Service Letter No. 438

SUBJECT: Clamping Priority Valve Actuating Cable

MODELS AFFECTED: PA-23-250 (six place) Aztecs, Serial Numbers 27-2505 to 27-2658 incl.

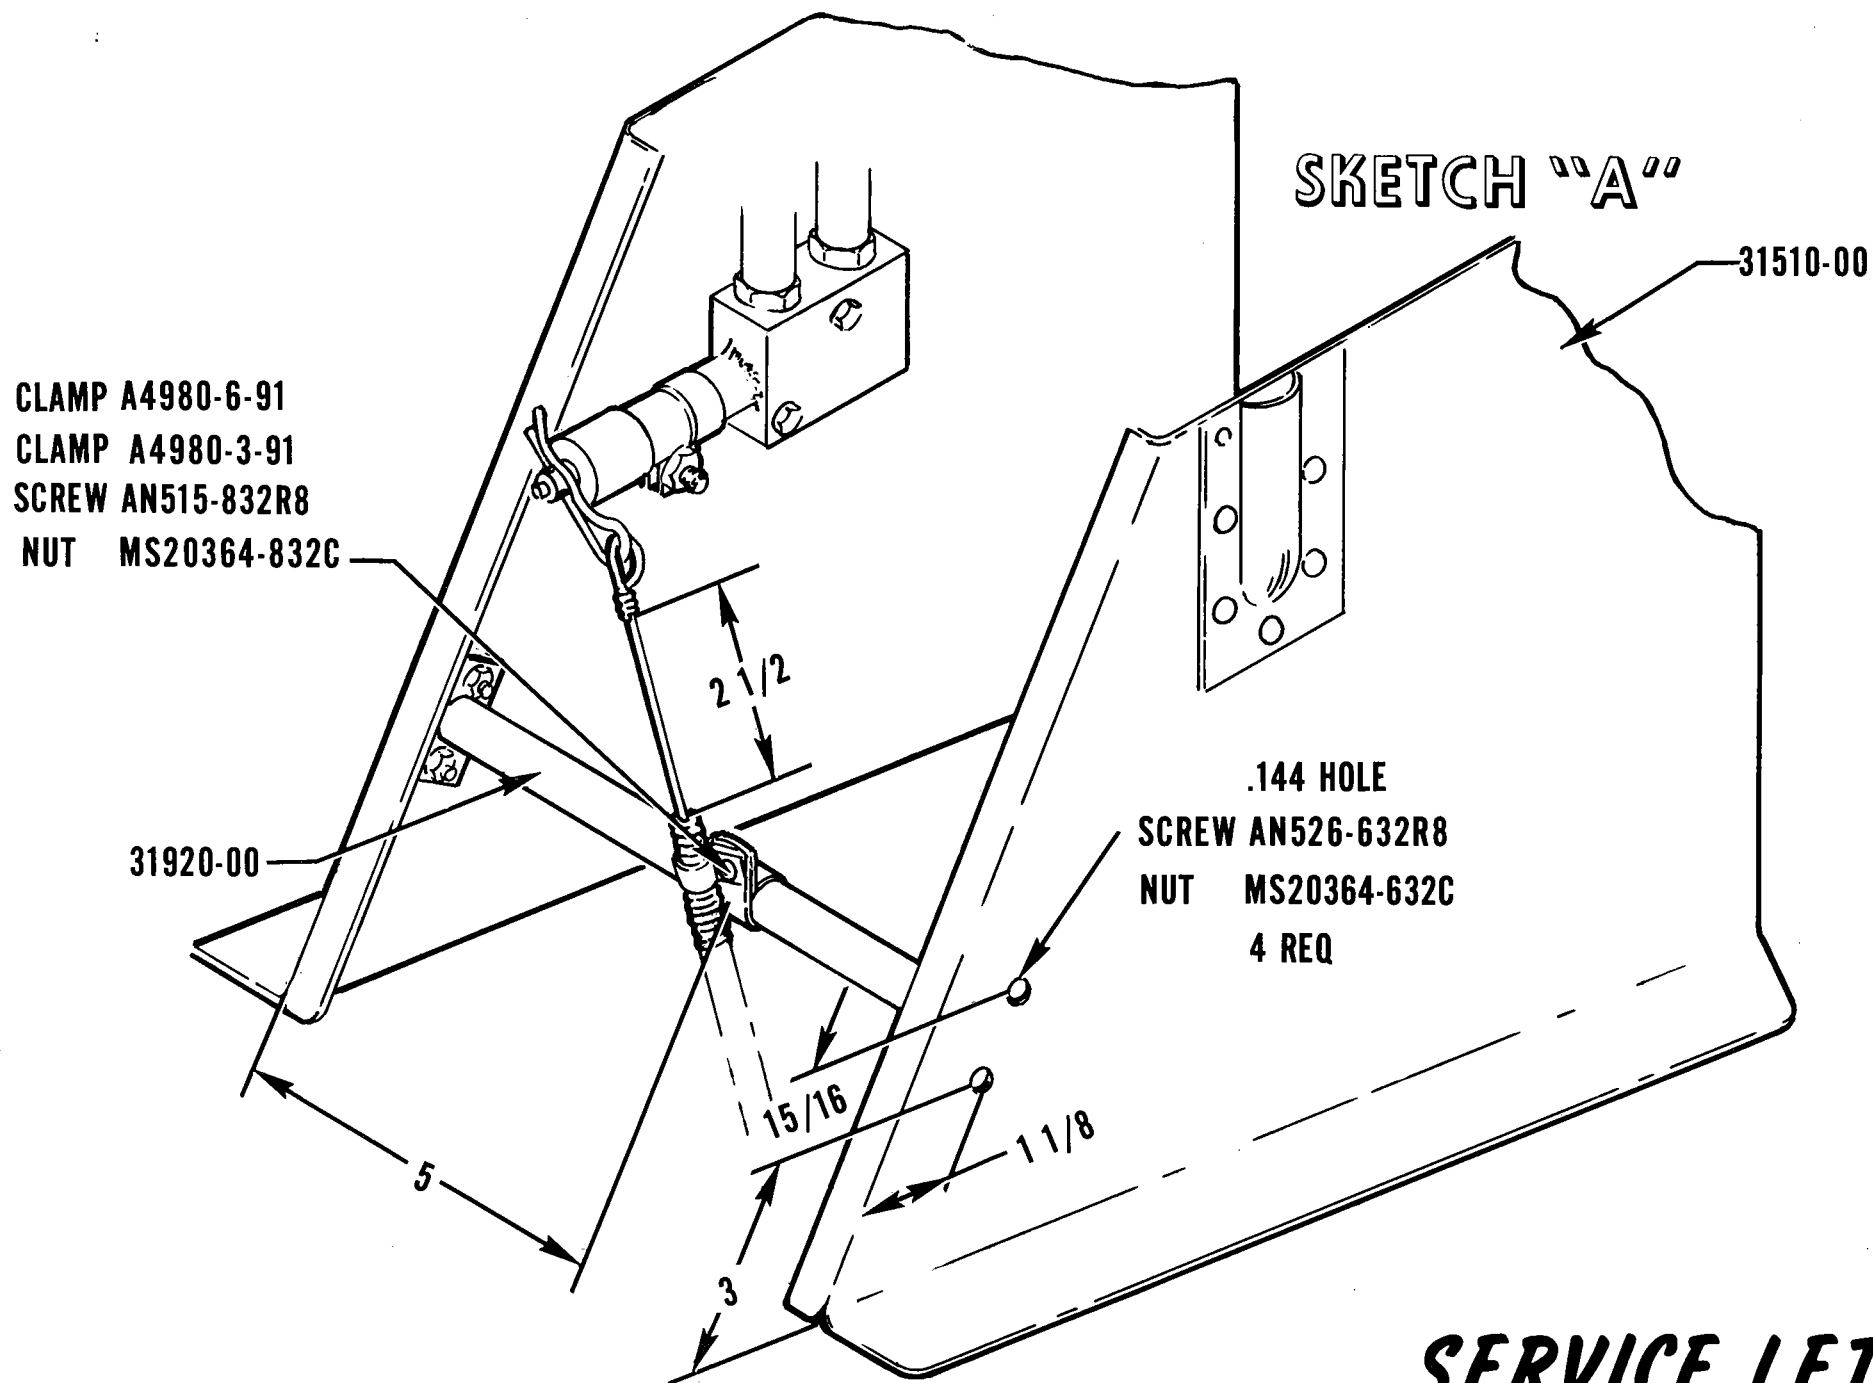
It is possible that flexing or slipping of the priority valve actuating cable may retard landing gear extension with the CO₂ system.

In order to prevent further flexing or slipping of this cable it is necessary that Kit Number 756 878 be installed in the aircraft listed above. Installation and cable rigging instructions will be included in each kit.

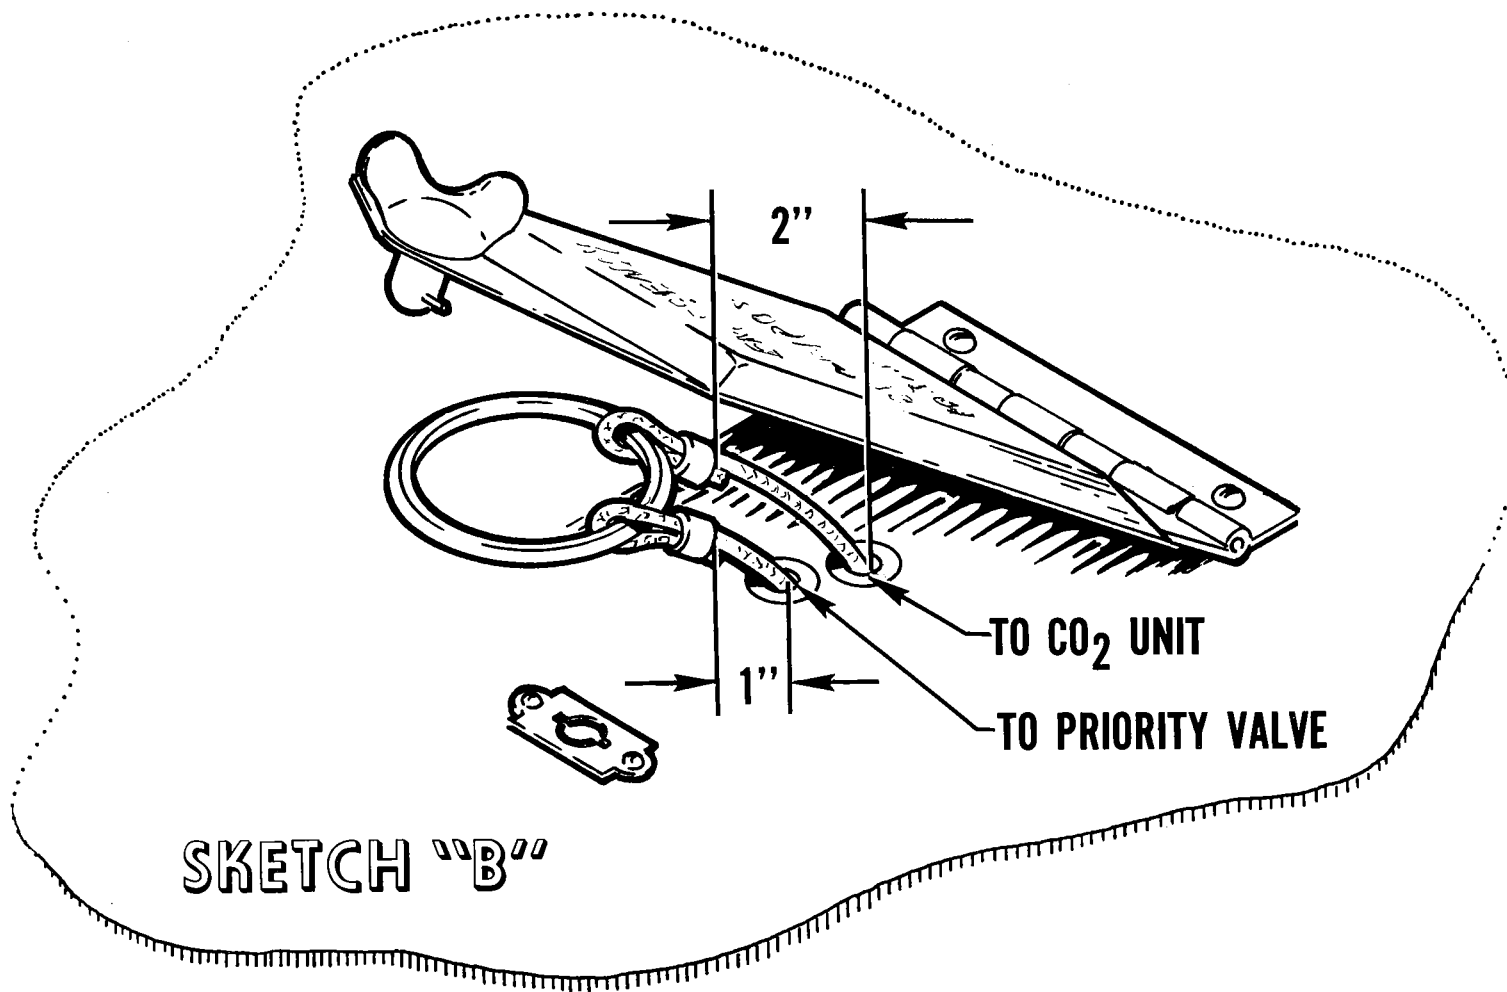
1. Remove CO₂ bottle from discharge unit.
2. Install tube and clamp in KIT 756 878 as shown in Sketch "A".
3. Check the 2 1/2 inch dimension on the end of the cable that is fastened to the pin in the priority valve, as shown in Sketch "A" and tighten clamp. If necessary, cut end of flexible housing, as a dimension of 2 1/2 inches must be maintained.

4. Lift the emergency gear extension cover located under the pilot's seat. Gently pull on the ring until all of the slack is taken up in the cable to the priority valve.

5. Gently take up the slack in the cable to the CO₂ discharge unit so that it will slide up the ring as shown in Sketch "B". The CO₂ cable should be 1 inch longer than the priority valve cable at this point.

6. This will give you the proper rigging of the cables to mechanically open the priority valve before introducing CO₂ to the system.
7. Replace CO₂ bottle in discharge unit.
